Planning and Zoning Commission - Regular Meeting

June 18, 2026 - 5:30 PM

26-2360 Consideration of a request from Hanover Property Company for a Preliminary Plat of M3 Ranch, Phase 3, being 157.17 acres located in the 1600 to 2300 Blocks of FM 917 (Heritage Parkway) and situated in the Crawford Treese Survey, Abstract No. 831, Joseph C Guest Survey, Abstract No. 311, Authur Gibson Survey, Abstract No. 302, and The RB & FA English Survey, Abstract No. 254. (SD26-017)

PP XX-XXXX
PRELIMINARY PLAT
FOR
M3 RANCH PHASE 3

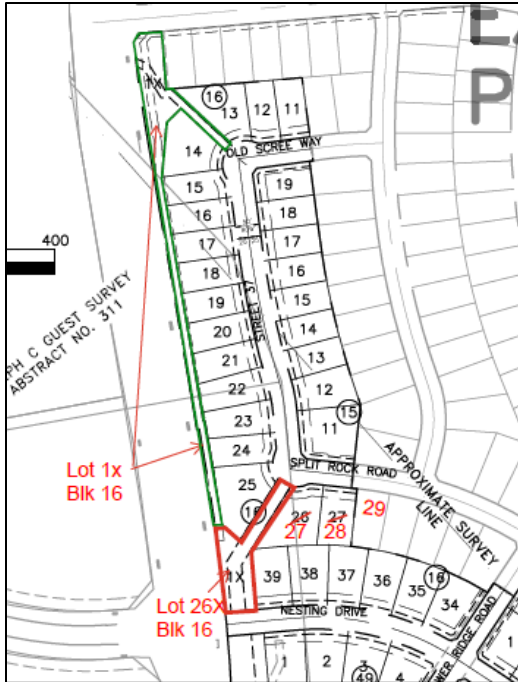
11. When numbering lots, if a block has an HOA lot, use a different lot number for the HOA lot than the rest of the block. For example, Lot 1X, Block 58, there is already a Lot 1, Block 58 so the HOA lot should be Lot 28X, Block 58 instead.

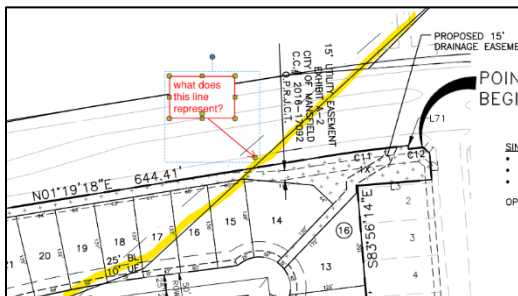
14. The lot number 28 is missing from block 16, to correct this, divide the HOA lot into two lots numbering one Lot 1X and the other Lot 26X (and change lots 26 and 27 to 27 and 28. See diagram below:

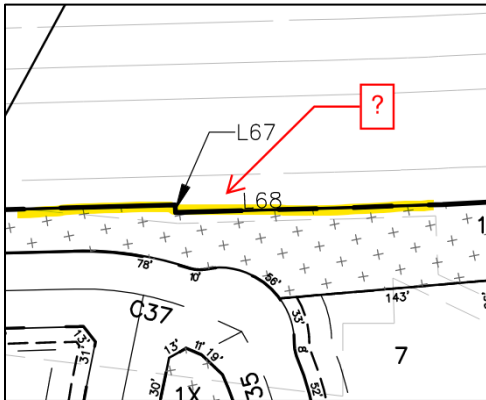
19. Label the unidentified linework highlighted below.

20. Clean linework upon Civil Plan and Final Plat submittal. See highlight below of two adjacent lines.

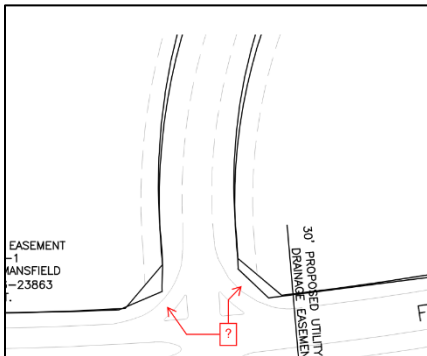
21. Upon Civil Plan and Final Plat submittal, confirm presence of line L67 and determine if the property line offset can be eliminated.
